JOINT REGIONAL PLANNING PANEL

SUPPLEMENTARY MEMO

JRPP No	2015STH002
DA Number	18/2015
Local Government Area	Shellharbour
Proposed Development	Extension of Dunmore Sand Extraction, Emplacement of Potential Acid Sulfate Soils & Rehabilitation
Location	Lot 21 DP 653009, 44 Buckleys Road Dunmore
Date	1 July 2016
Report by	Victoria Nicholson, Senior Development Assessment Officer

Figure 2 Proposed noise barrier location.

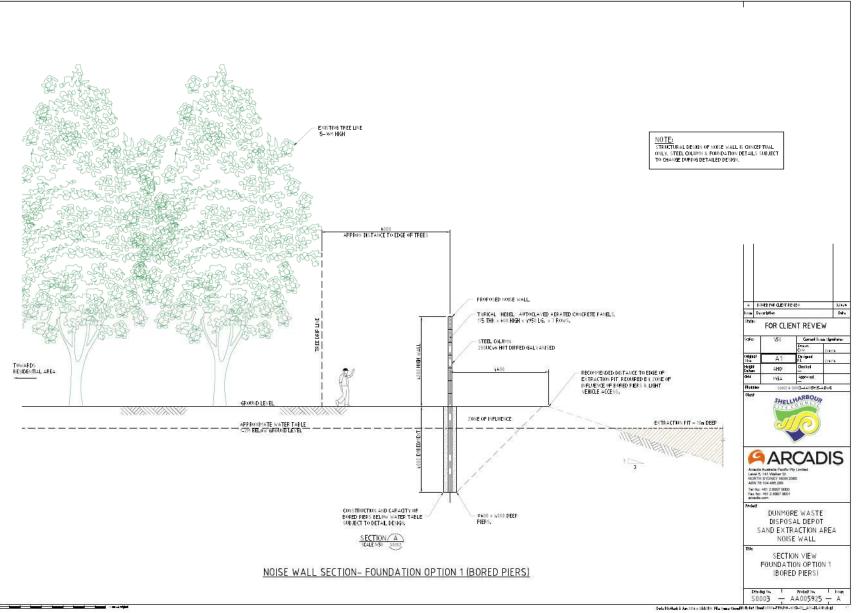
Therefore, the location of the proposed noise barrier has been reviewed considering potential ancillary impacts from flooding, visual impact, loss of habitat and encroachment on mining area and resultant noise mitigation. Figure 2 shows the preferred location of the noise barrier.

An iterative approach was used and it was found that a 5.2m barrier would reduce noise levels from sand extraction and site rehabilitation to below the PSNL.

However when considering the most reasonable and feasible barrier it was found that a 4m noise barrier would reduce noise levels for sand extraction to within the PSNL however for site rehabilitation a negligible 1dB exceedance occurs at 1 Dunmore Rd and 5 Dunmore Rd (See Table 2).

The exceedance of 1 dB for the site rehabilitation could be easily reduced if the long armed excavator were to have its source noise level reduced by 1dB by possibly increasing the transmission loss of the engine enclosure by cladding with wavebar, or similar.

The predicted noise levels for the site rehabilitation with the recommended mitigation, specifically a 4 m barrier and a long armed excavator with a 1 dB reduction in noise level, is presented in Table 3.
